Kentucky Transportation Cabinet Value Engineering Study

Mountain Parkway Item No. 10-166.00 Magoffin County

Value Engineering Study Report

Study Dates: May 23-25, 2016

VALUE ENGINEERING PROPOSAL M-08
Kentucky Transportation Cabinet
Mountain Parkway 10-166.00 Project

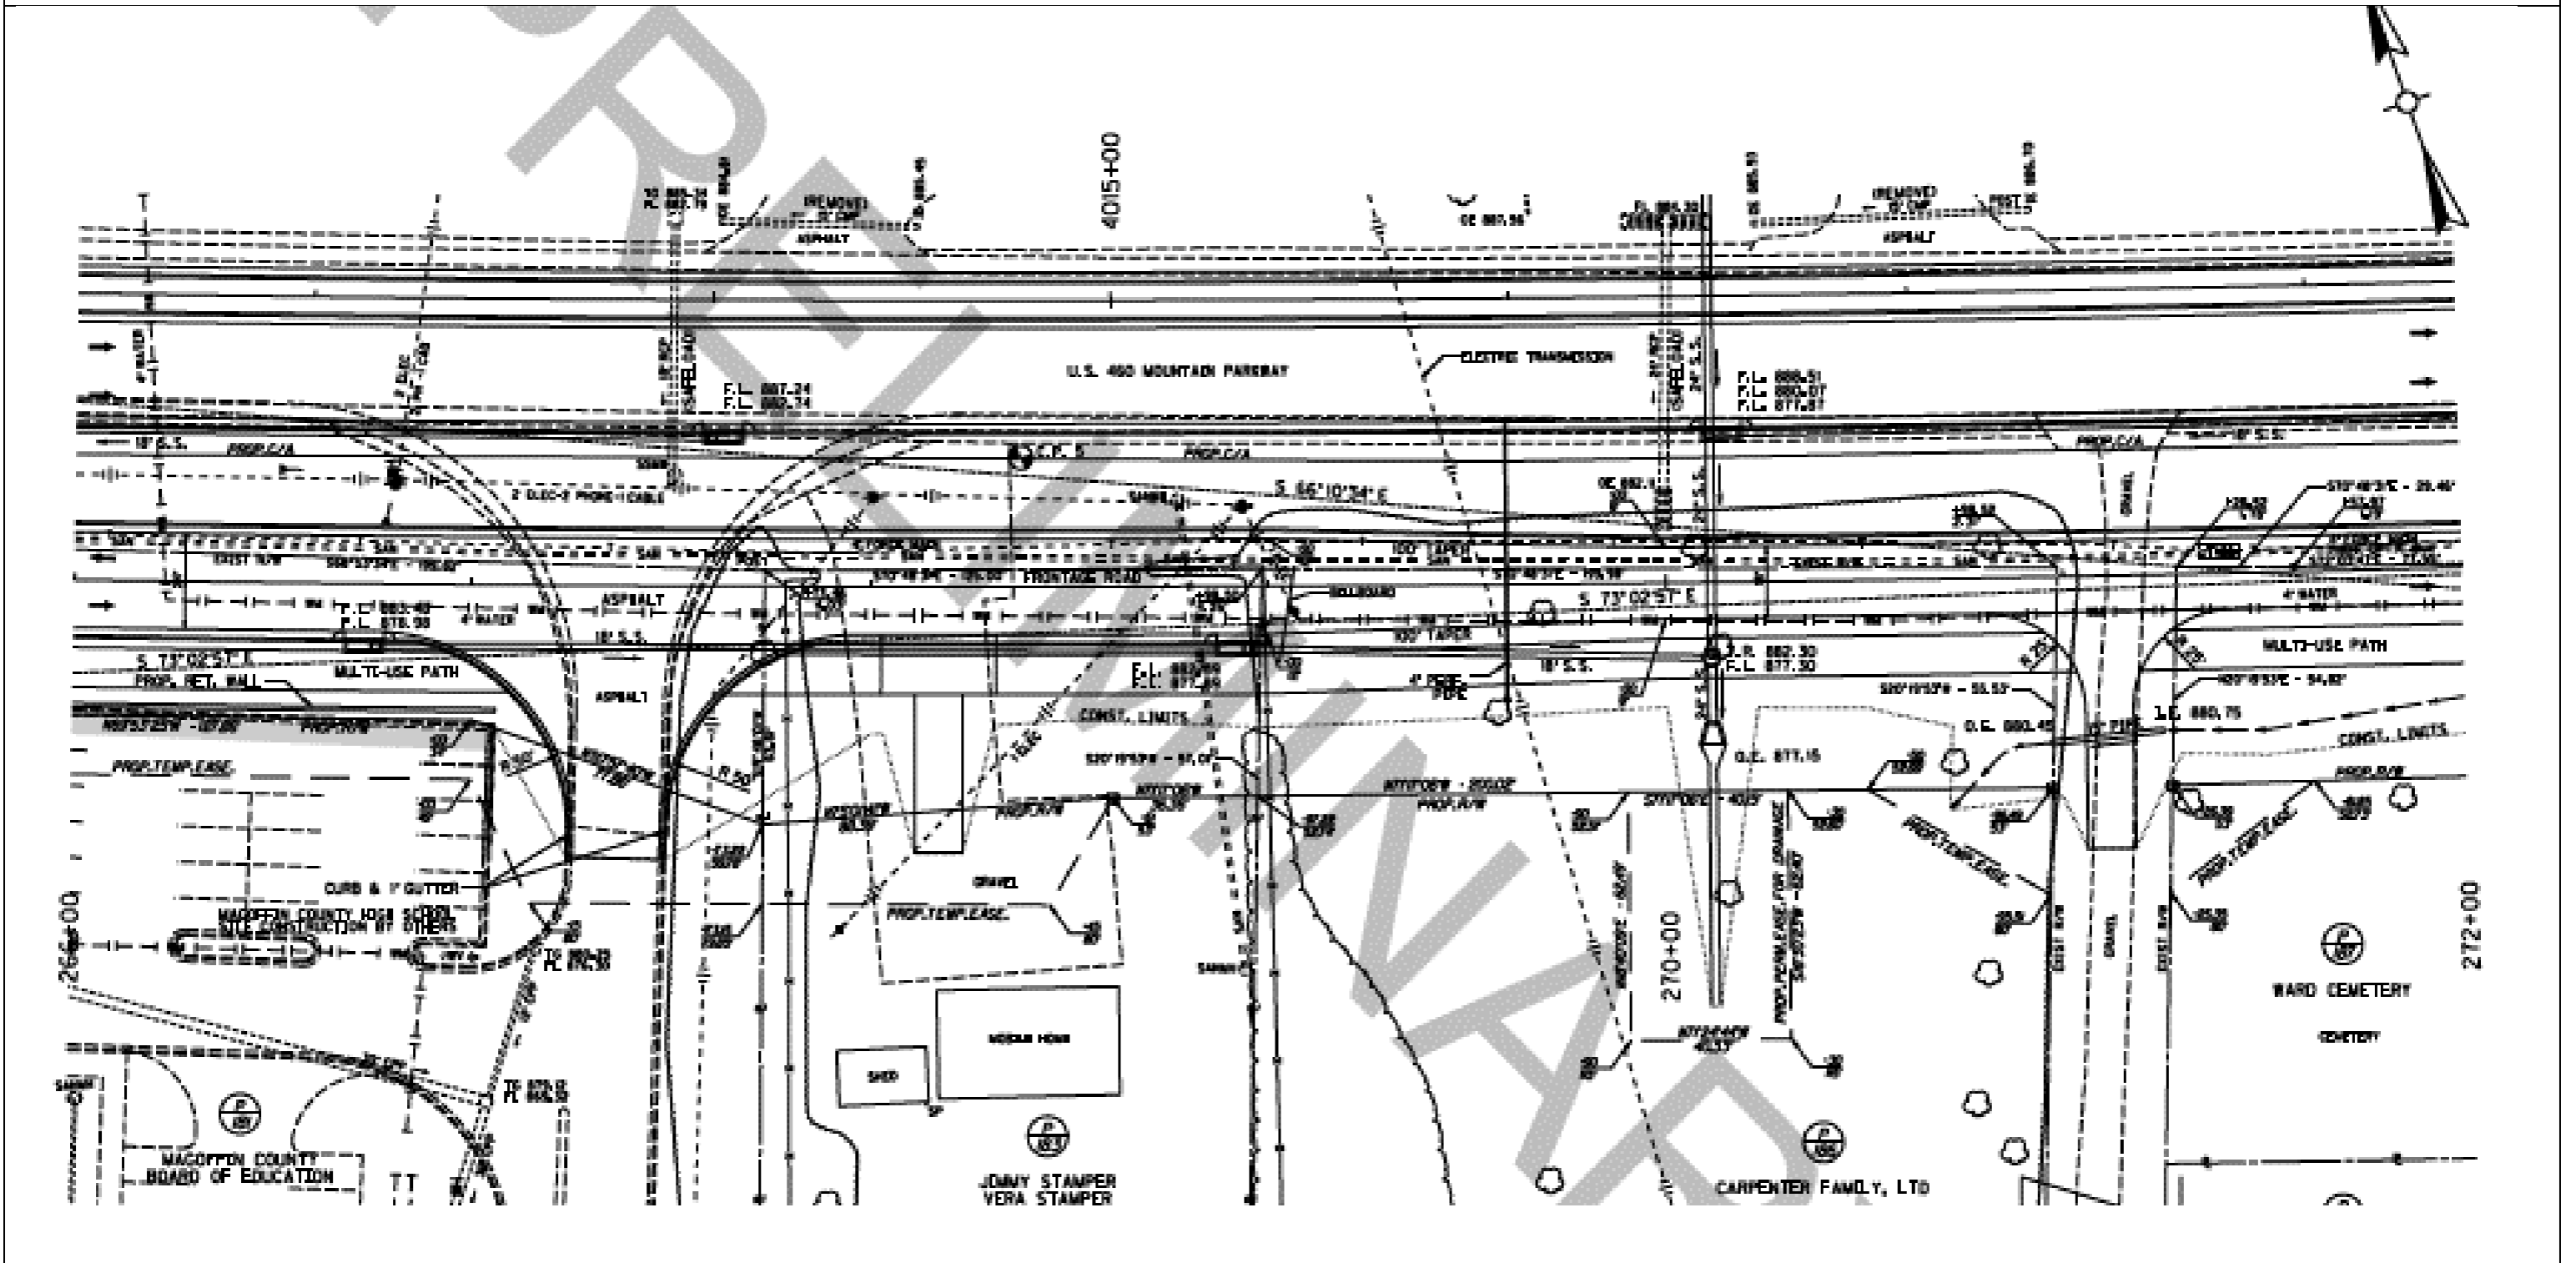
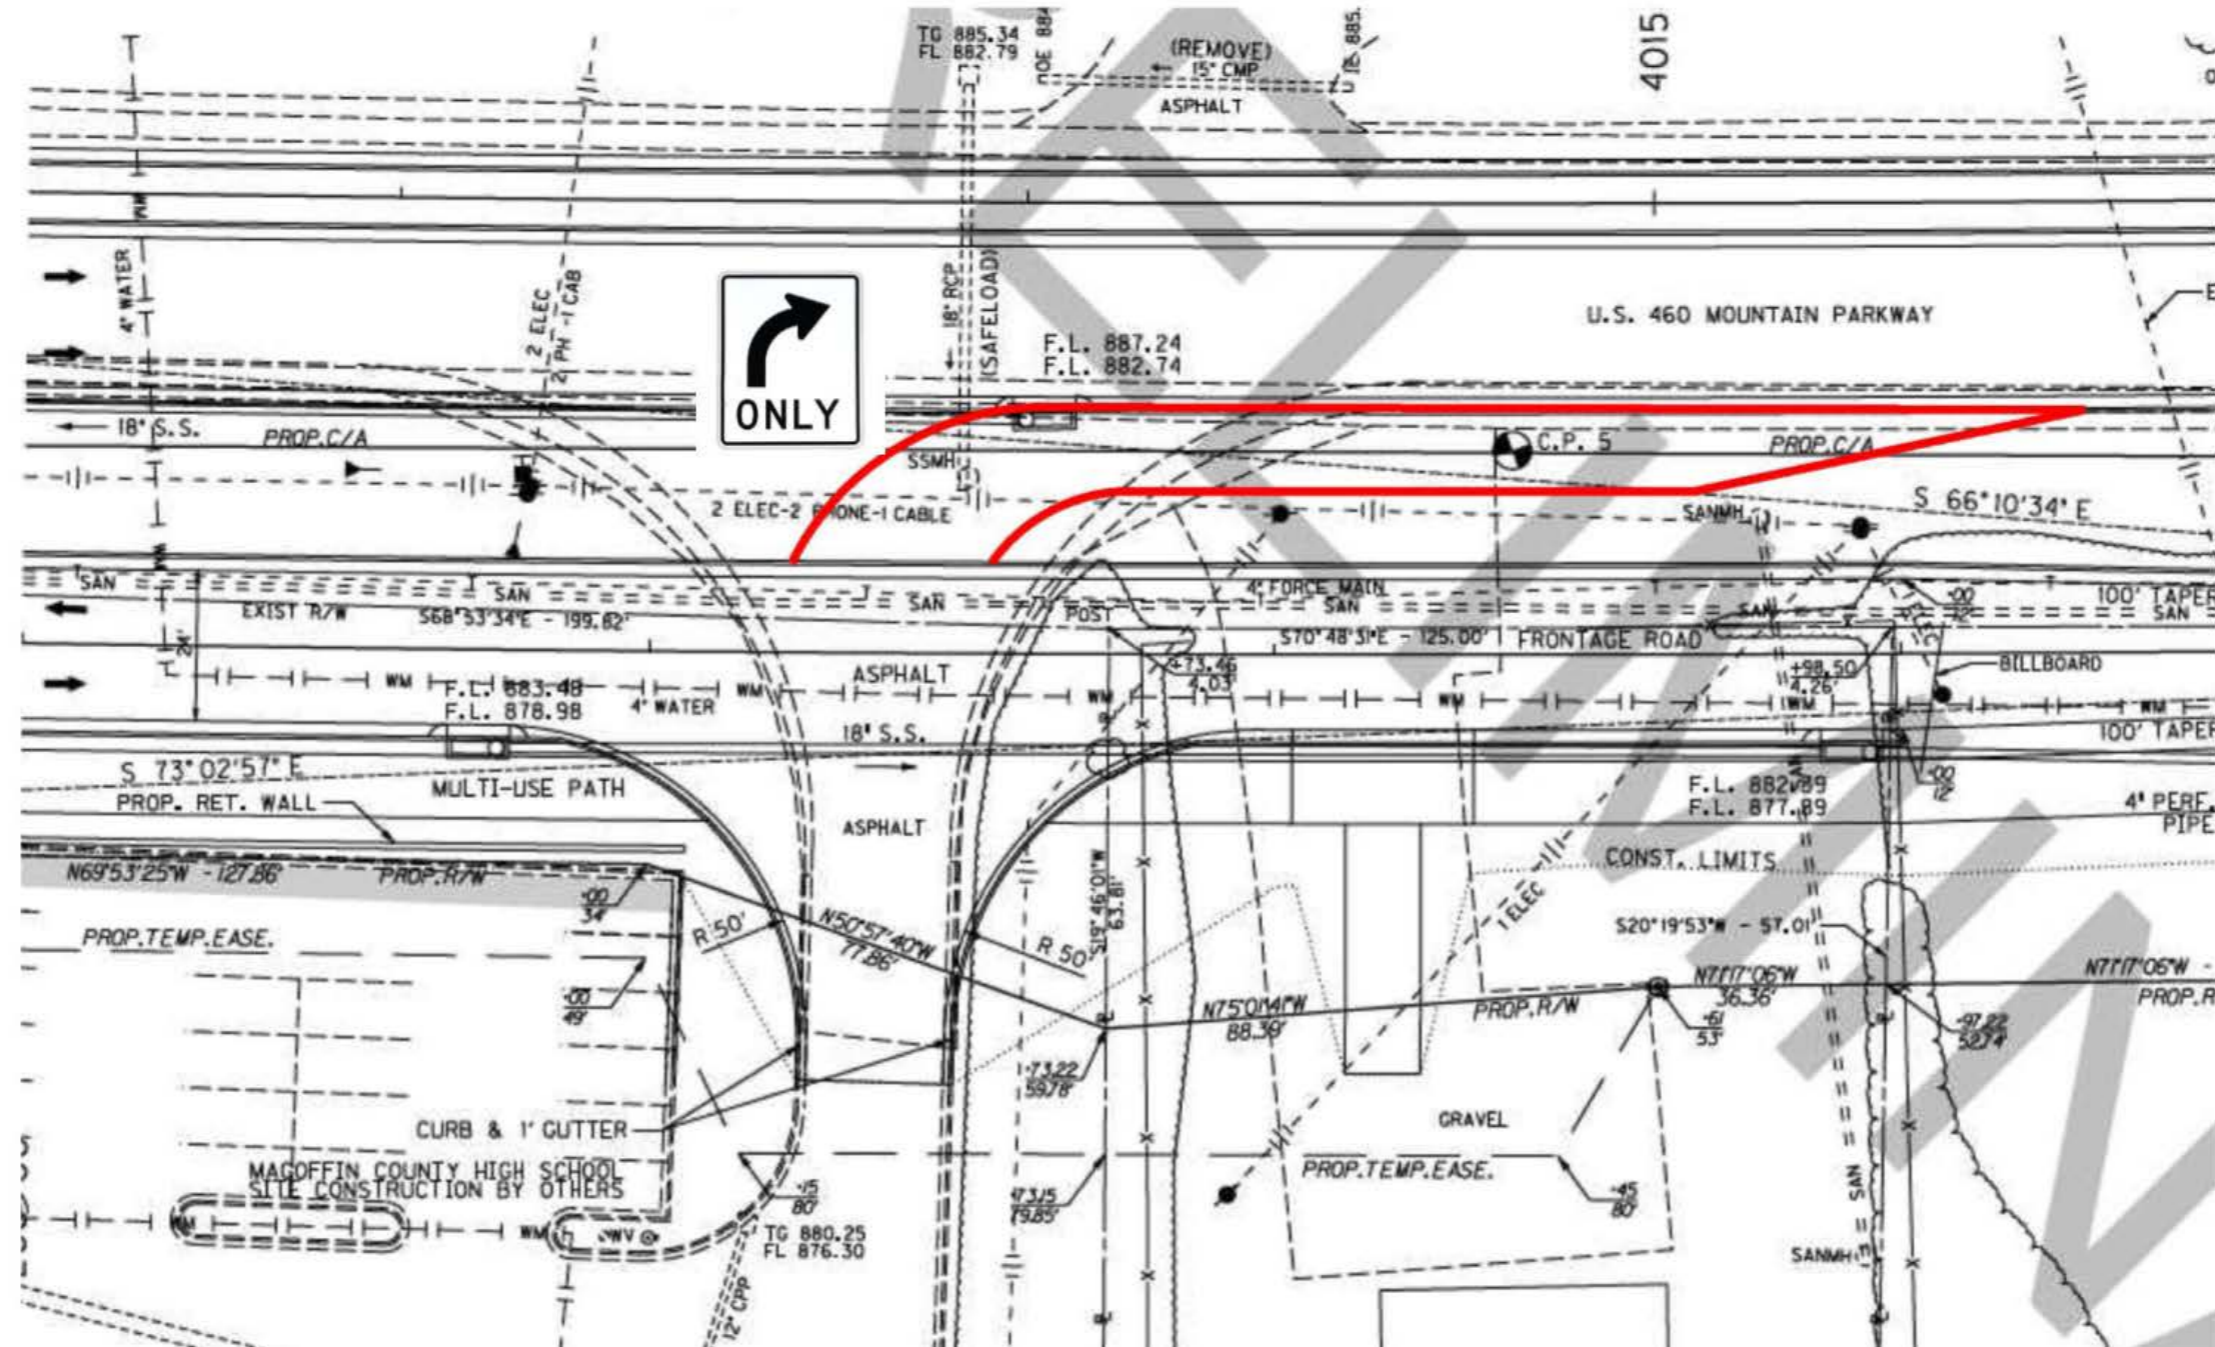
TITLE:	Add right-out for high school to mainline
DISCUSSION/JUSTIFICATION:	
<p>The new Magoffin County High School traffic will be forced to use only one exit point. The frontage road they will use is in close proximity to the mainline and therefore will provide a minimal amount of storage for vehicles accessing the mainline. During dismissal, the queues with buses trying to access both east and west will impact mainline for a greater period of time. With the additional exit, buses and cars traveling east will be provided access to the mainline without utilizing Burning Fork road and should reduce the length of time the buses and cars to have impact on mainline traffic. This will greatly reduce impact the frontage road and Burning Fork Rd in the morning, afternoon, and during school events.</p> <p>The proposed change is to provide a Right-out only access to the east of the high school and eliminate the dead end. The challenge that this may pose is that it is likely that others will use the access point in lieu to avoid having to use the the light at the intersection. There would be a need to sign the roadway stating 'Local Traffic Only' and/or there may be a need to limit the access of large trucks to keep traffic in front of the school to a minimum.</p>

IMPLEMENTATION CONSIDERATIONS:	
<p>Providing an exit to the mainline in line with the exit onto the frontage road will require additional costs in re-design, additional asphalt, and additional drainage structures.</p>
